# UNITED STATES PATENT AND TRADEMARK OFFICE

APPLICATION NO.	FILING DATE	FIRST NAMED INVENTOR	ATTORNEY DOCKET NO.	CONFIRMATION NO.
10/600,712	06/23/2003	Michael Francis Dube	14150-00601	5751
826	7590	06/10/2009	EXAMINER	
ALSTON & BIRD LLP			FELTON, MICHAEL J	
BANK OF AMERICA PLAZA				
101 SOUTH TRYON STREET, SUITE 4000			ART UNIT	PAPER NUMBER
CHARLOTTE, NC 28280-4000			1791	
			MAIL DATE	DELIVERY MODE
			06/10/2009	PAPER

<b>Office Action Summary</b>	<b>Application No.</b>	<b>Applicant(s)</b>	
	10/600,712	DUBE ET AL.	
	<b>Examiner</b>	<b>Art Unit</b>	
	MICHAEL J. FELTON	1791

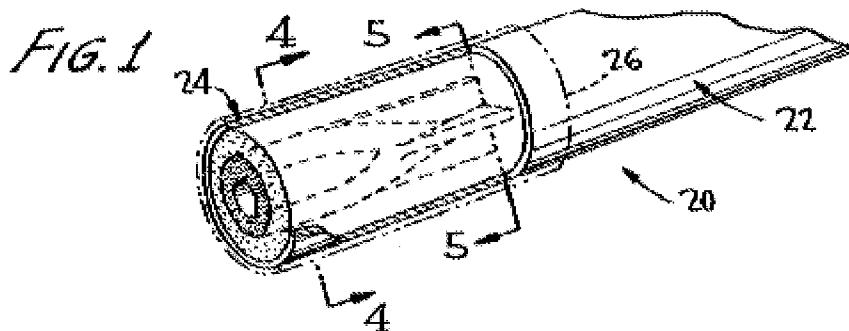
7. Regarding claim 61-64, 67, 70, 73-75, 78-81, 83, 84, 86, 87, 90, and 96-99 Berger discloses a cigarette with a filter element that is an outer cylindrical shape and an inner filter member made from steam bonded cellulose acetate (see figure 1 below regarding shape, col. 6, 2-9 and col. 3, 34-53 regarding steam bonding and cellulose acetate). The inner filter member has a cavity that has a cylindrical end and a conical end and on the other side of the conical end is a crimped structure in the shape of a cross. Figure 1 illustrates the open end of the cavity distal to the tobacco rod, however, Berger discloses that it would be reasonable to reverse the orientation (col. 4, line 67-- col. 5, line 7).

14. Regarding claim 72, Berger (figure 1) shows the cavity occupying approximately half the length of the filter.
